RE: DRAINAGE PLAN FOR ELECTRIC MOTOR CO. (G16-D99)  
ENGINEER'S STAMP DATED 12/1/94.

## ***CERTIFICATE OF COMPLETION AND ACCEPTANCE***

**RE: PROJECT NO. 4940.80 Del Norte Wellness Center  
MAP (D-19)**

GRADING & DRAINAGE PLAN  
ELECTRIC MOTOR CO.

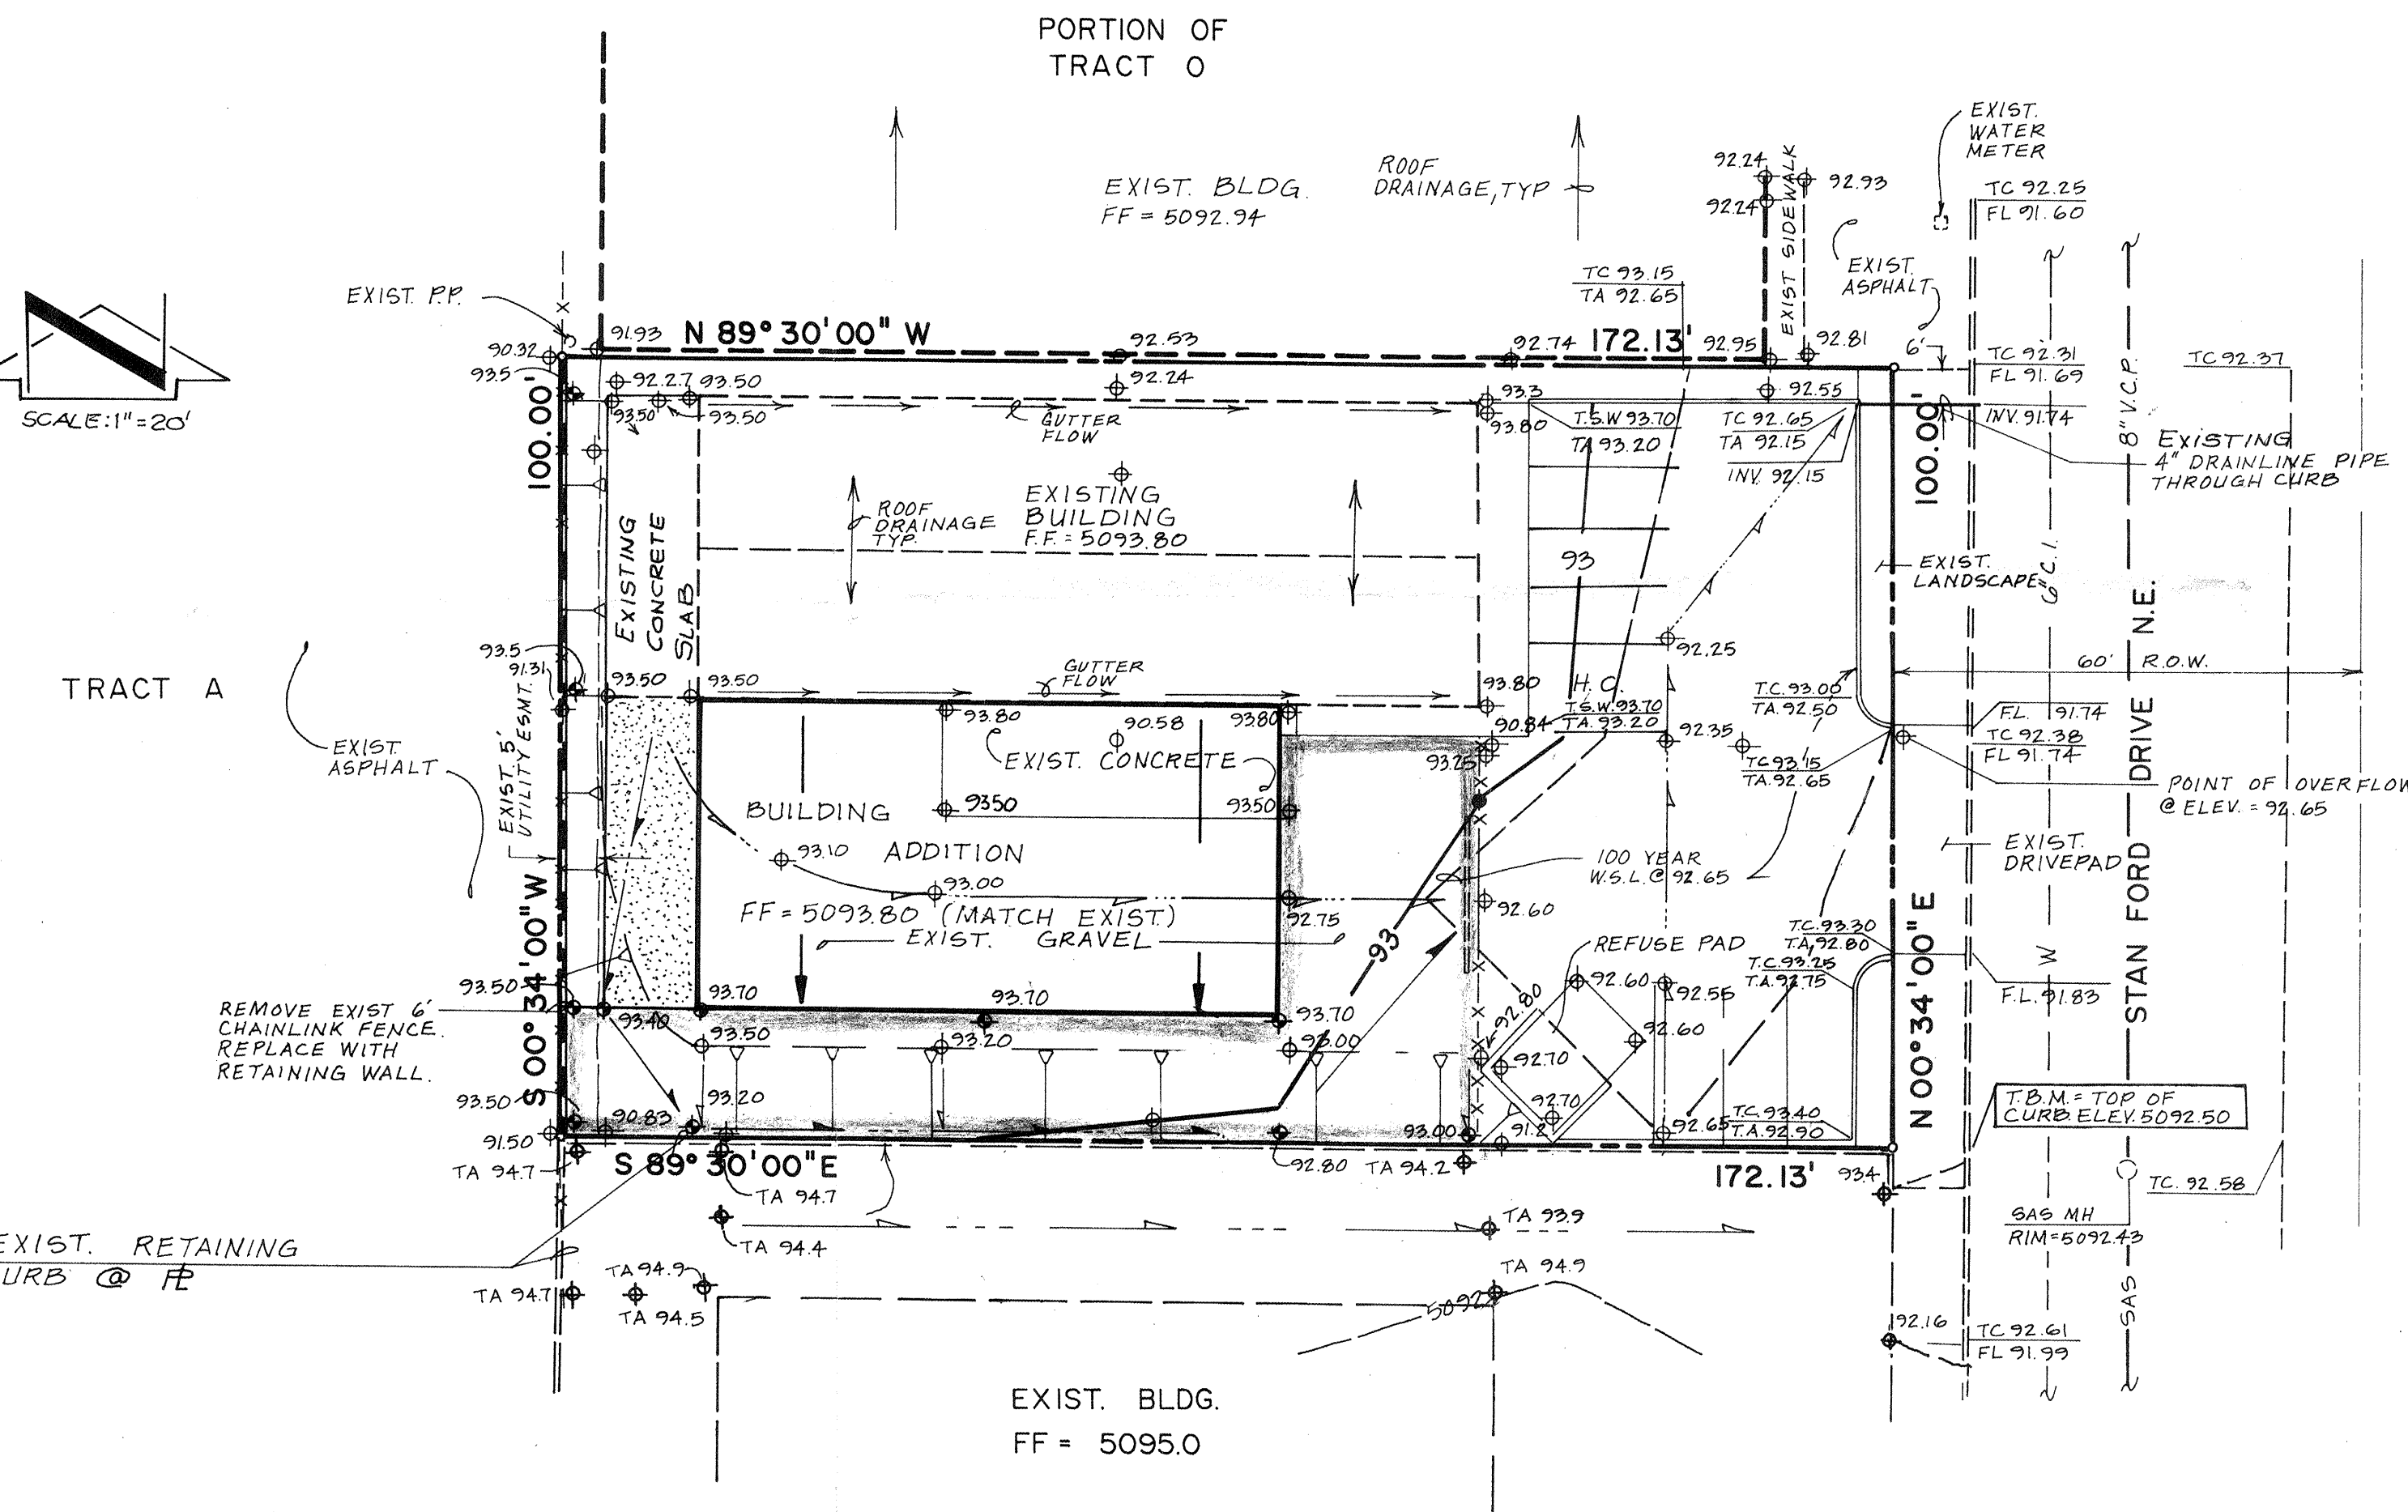
Based on the information provided on your December 2, 1994 submittal, the above referenced site is approved for Building Permit.

Please attach a copy of this approved plan to the construction sets prior to sign-off by Hydrology.
